PLK DESIGN 2 (6) replaces PLK DESIGN 1 (5) and most PLK DESIGN 1 (5) C-numbers
Where applicable, PLK DESIGN 1 (5) and C-numbers have been automatically converted

PLK DESIGN 2 (6)

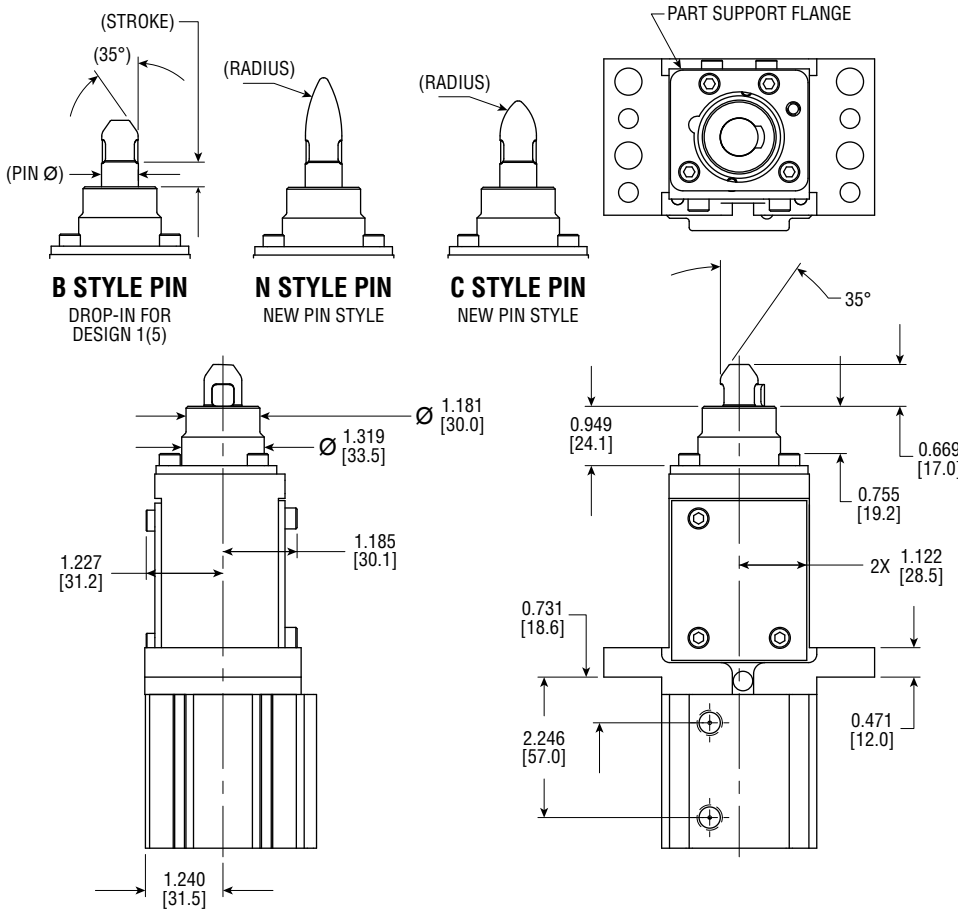
Previous PLK DESIGN 1 (5) and associated C-numbers are only available as Unique Solutions®.

PIN Ø = PIN Ø SPECIFIED = +0.00 / -0.02 mm
 (+0.0000 / -0.0008 in)

PIN Ø AVAILABLE FROM 12.00 mm TO 30.00 mm

FIGURE 2

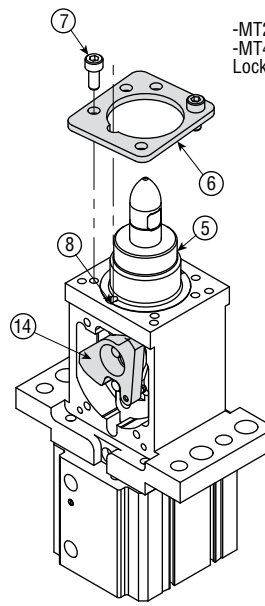
- 1) Start in the unclamped position, with the pin up, and the finger(s) retracted into the pin.
- 2) Install the part support (item 5) with the adjustment slot over the adjustment screw (item 8). Install the flange plate over the part support aligning the adjustment screw and two holes as shown. Hand tighten two times (item 7). (See Figures 1 and 2.)

NOTE ADJUSTMENT SCREW ALIGNED WITH PART SUPPORT SLOT AND FLANGE SLOT

FIGURE 3

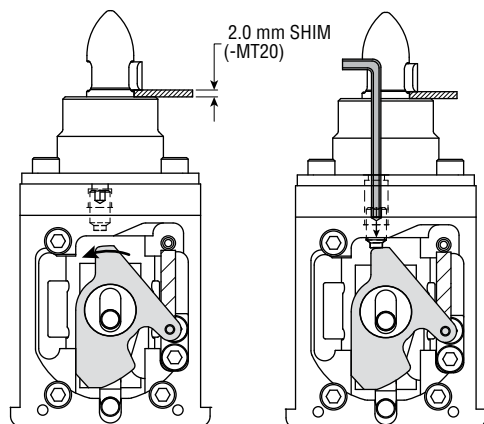
- 3) Install the shims to match the panel thickness requested. Close the clamp on the shims with air pressure (87 psi).
- 4) Make sure the lock bracket (item 14) rotates counterclockwise into position under the adjustment screw (see Figure 3). Turn the adjustment screw clockwise until it contacts the top of the lock bracket (see Figure 4).

- 5) After touching, back the adjustment screw off one full turn to assure clearance so the lock bracket is free to rotate clockwise when the clamp opens (see Figure 5).
